Site: ABQ RV & Boat Storage - 2201 Vista Oriente St NW - H10E030 – NMR1000K2

Re: Drainage Ordinance (14-5-2-11) Violations for Erosion and Sediment Control

This is the 1st Violation Notice. During a routine inspection on 8/19/2021, the following violations were observed.

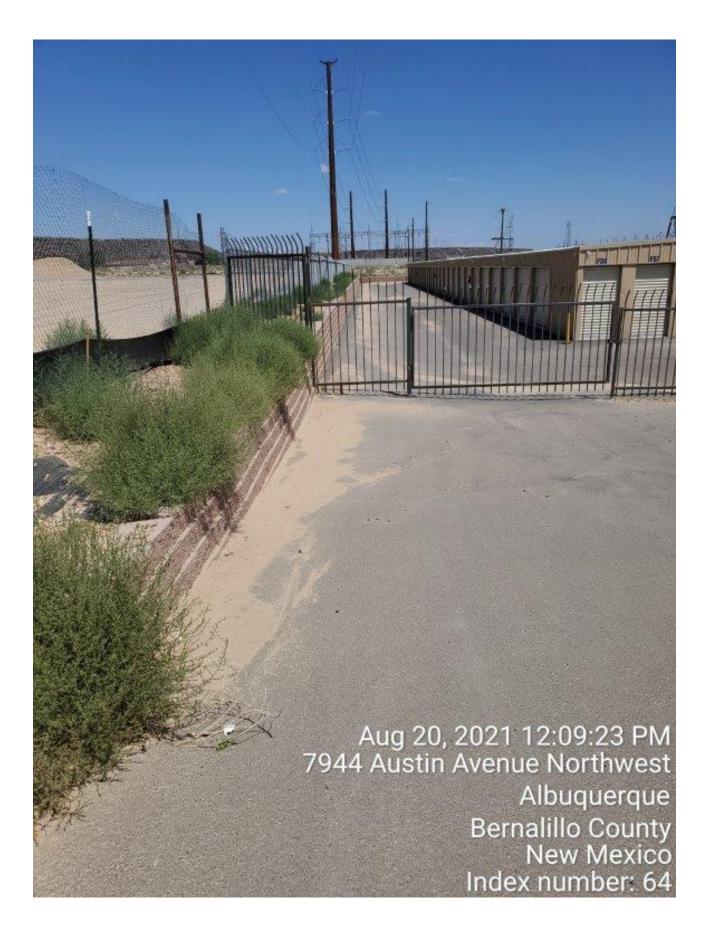
- 1) Failure to provide self-inspection reports when requested (1st Violation Notice)
- 2) The silt fence has fallen off of the stakes and is full of sediment(1st Violation Notice)
- 3) Concrete washout is on the ground outside of the lined container (1st Violation Notice)

At the inspection on 8/19/2021, the SWPPP was not available onsite. The washout facility is located in the northeast corner of the site, the low corner of the site. Drainage from most of this site goes through that corner and is likely to wash contaminants downstream. Some of the concrete washouts missed the lined container and were lying on the ground in the path of stormwater runoff. The concentrated drainage to that corner exceeds the capacity of the silt fence, as evidenced by the sediment that was washed downstream into the adjacent parking lot.

- 2) Direct wash water from concrete, paint, and stucco into a leak-proof container per CGP 2.3.4. The washout facility needs to be moved to a higher location out of the path of stormwater runoff. The concrete washout that is on the ground needs to be removed and disposed of in a proper construction waste container.

- 3) Where sediment has been tracked out from your site onto paved roads and sidewalks, remove the deposited sediment by the end of the same business day CGP 2.2.4.d. Remove the sediment that has been washed into the neighbors parking lot.
